ADDENDUM NUMBER THREE
TO THE CONTRACT DOCUMENTS FOR CONSTRUCTION OF
ORANGE BEACH RECREATION COMPLEX
NEW BASEBALL/SOFTBALL FIELD RENOVATIONS AT ORANGE BEACH SPORTSPLEX
CITY OF ORANGE BEACH

This addendum forms a part of the Contract Documents and modifies the Bid Documents dated May 4, 2020.

This Addendum consists of three (3) page Addendum, one (1) general documents, one (1) Specification & thirteen (13) full-size sheets.

C200

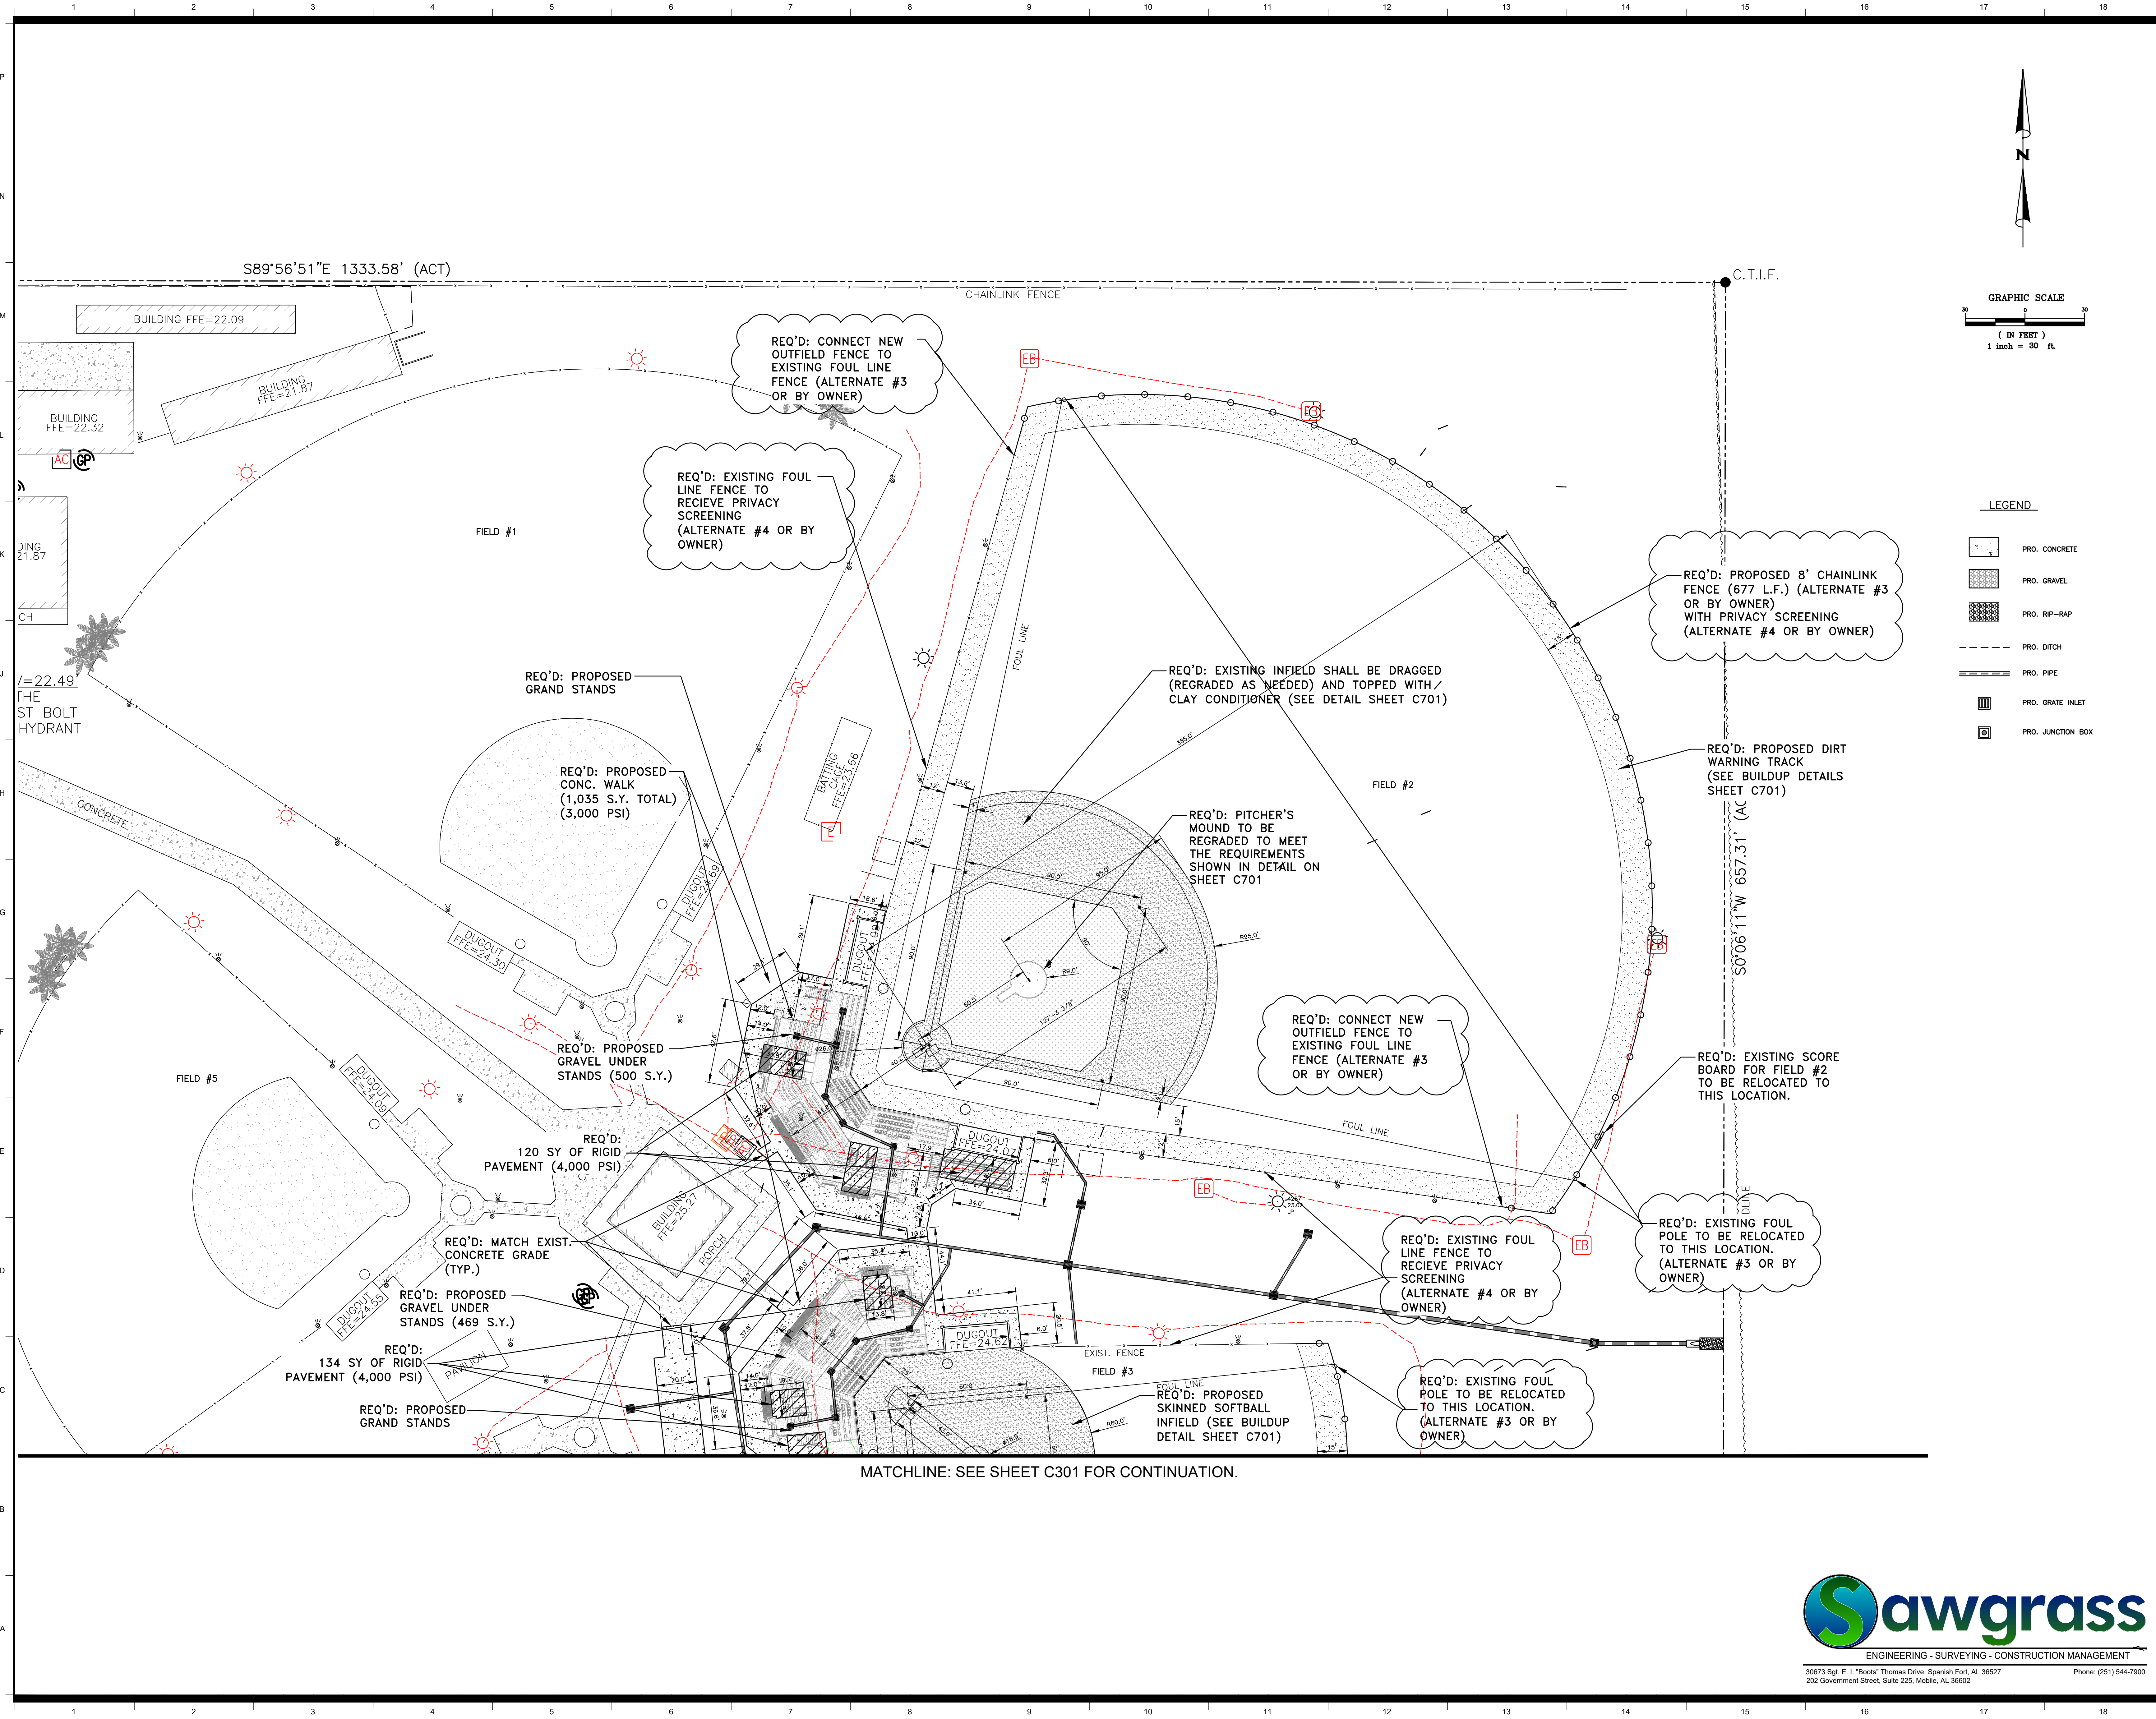
ITEM 01 SHEET C200 – EXISTING CONDITIONS & DEMOLITION PLAN
Reissue Sheet in its entirety.
1. Notes addressing the removal of the existing outfield fence as part of alternate #3 have been revised to be part of the base bid.
2. Removal and salvaging of the existing Foul Poles have been revised to be part of the base bid.
3. Added notes to clarify where existing foul lines fencing is to remain.

REQ'D: REMOVE 542 L.F. EXIST. FENCE (BASE BID)

C300

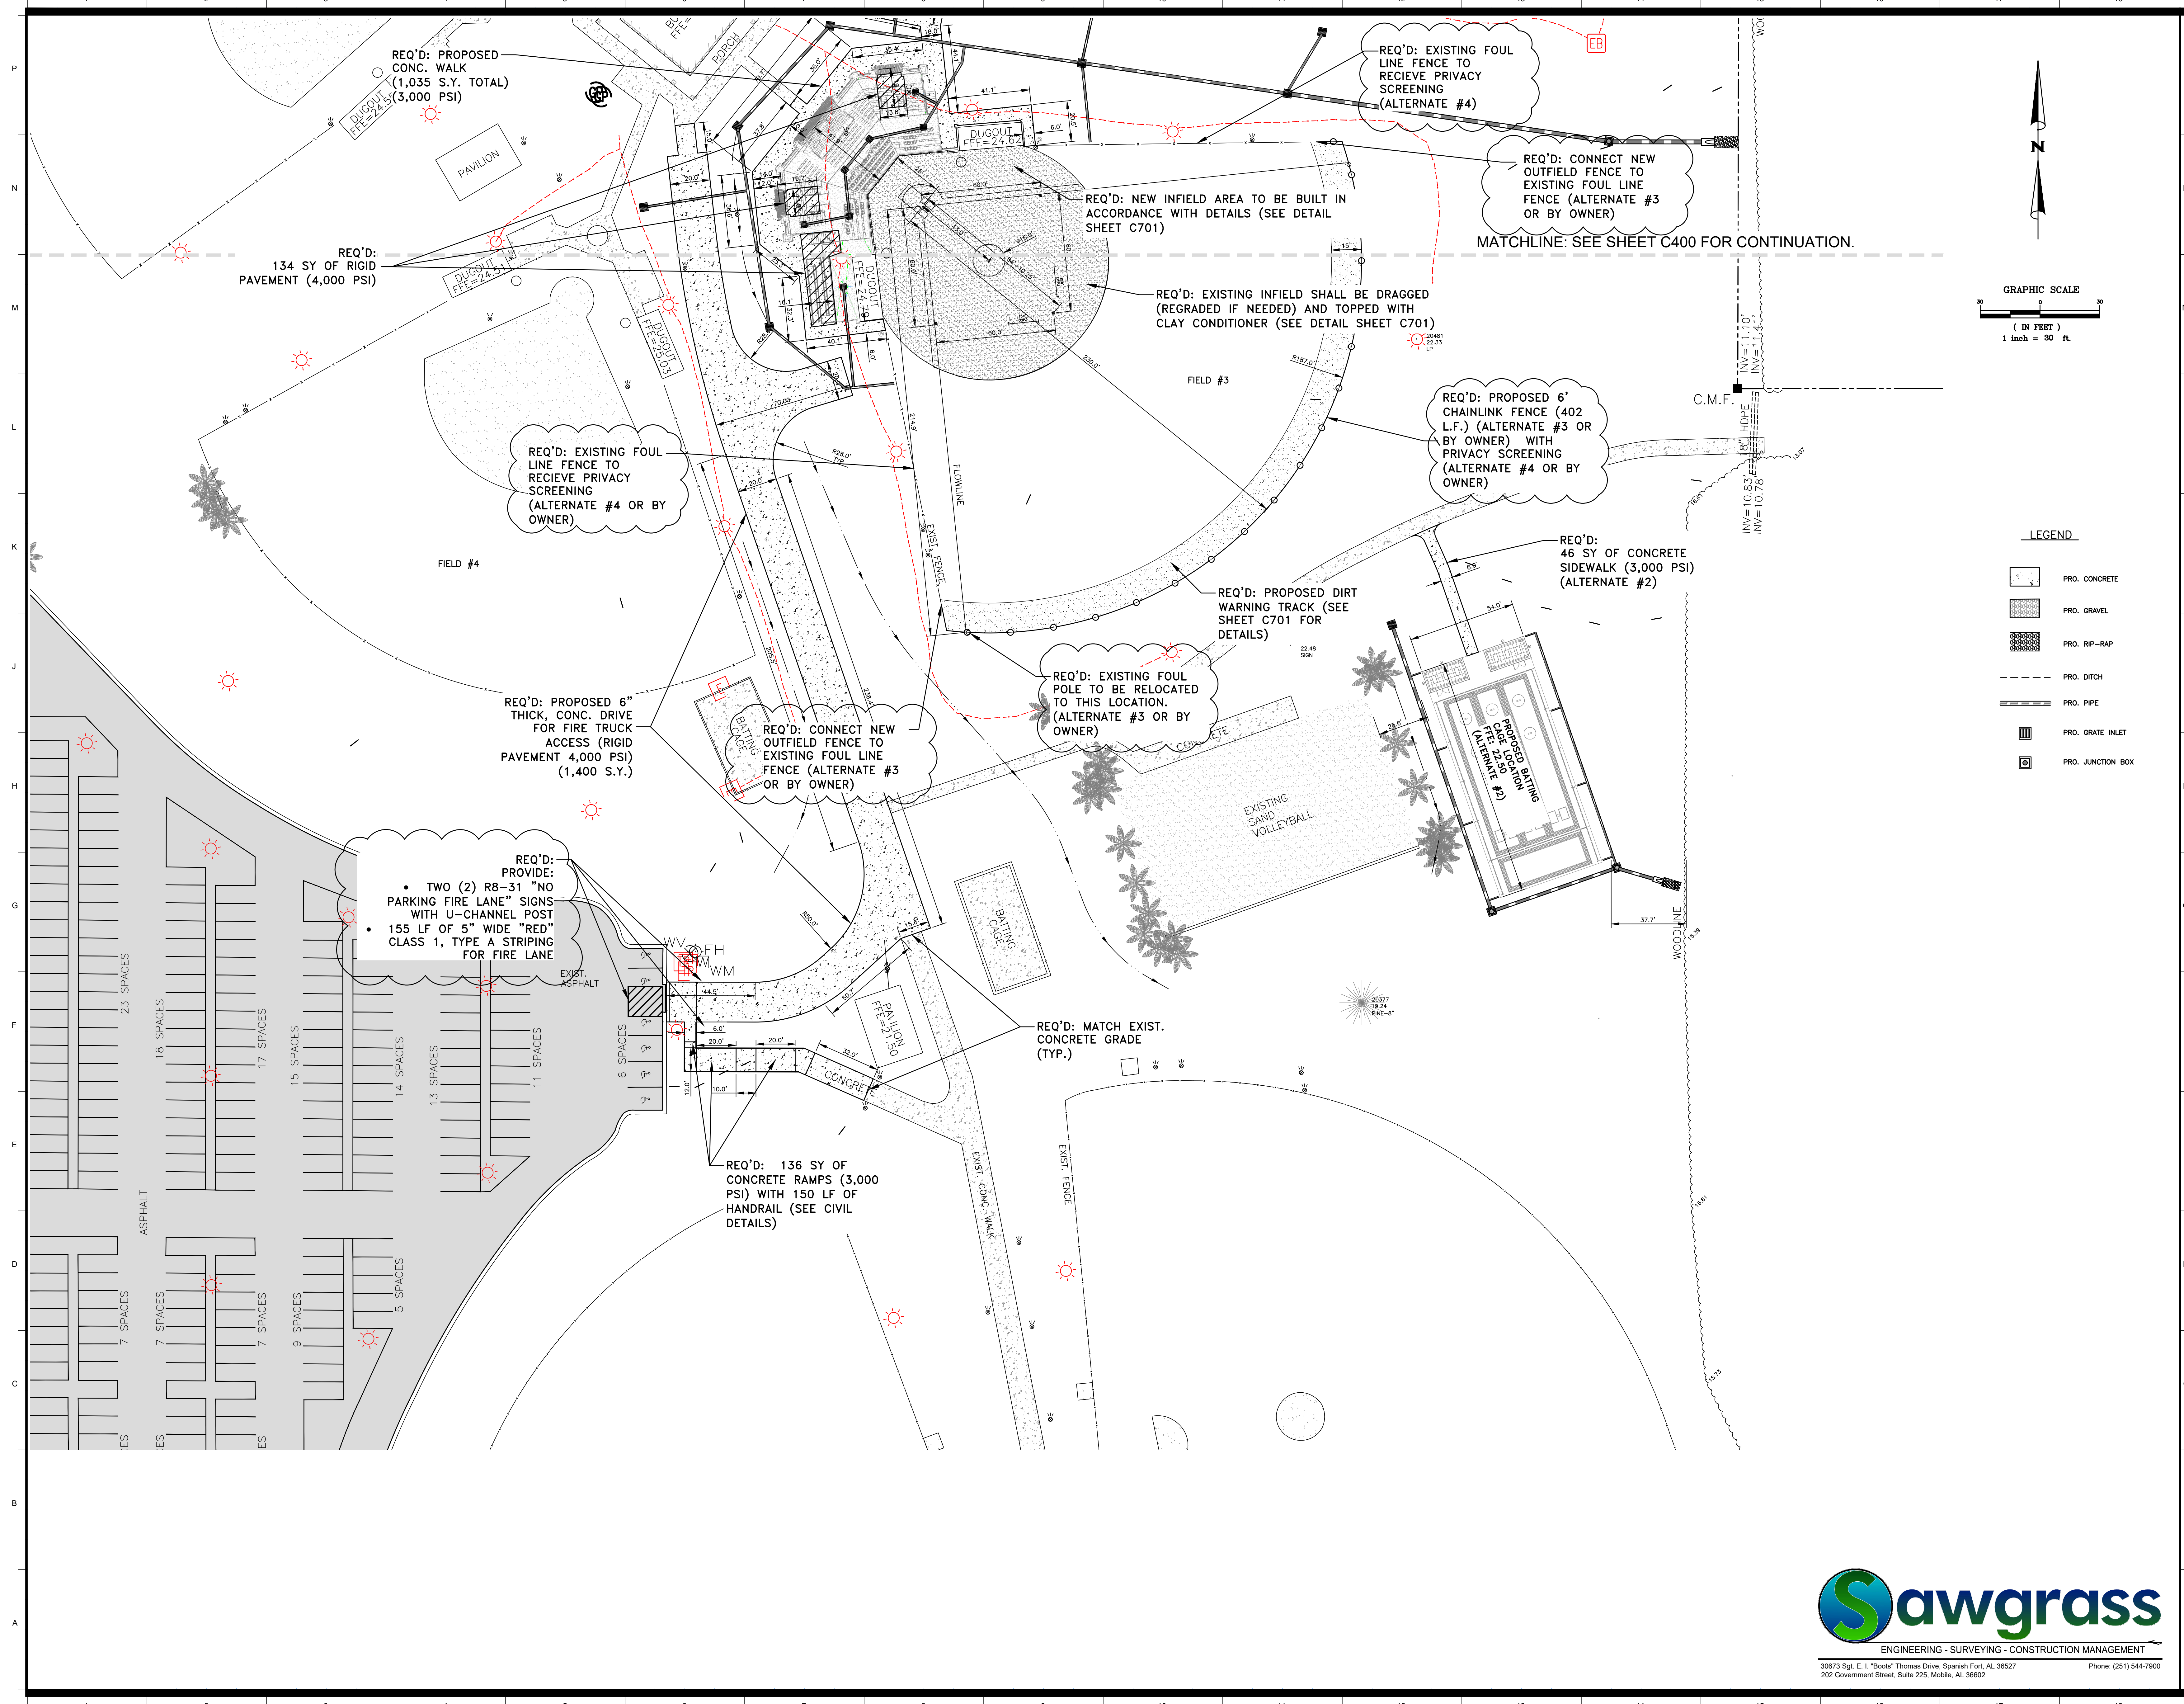
ITEM 02 SHEET C300 – GEOMETRY PLAN #1
Reissue Sheet in its entirety.
1. Revised the notes of the Outfield fencing of Field 3 to Clarify scope and alternates.
2. Add Notes
a. Directing the GC to connect the new outfield fence to the existing field fence.
b. Adding note showing additional areas where fence screening is required for Alternate #4.
c. Providing signage for fire lane and painting the ground with striping.
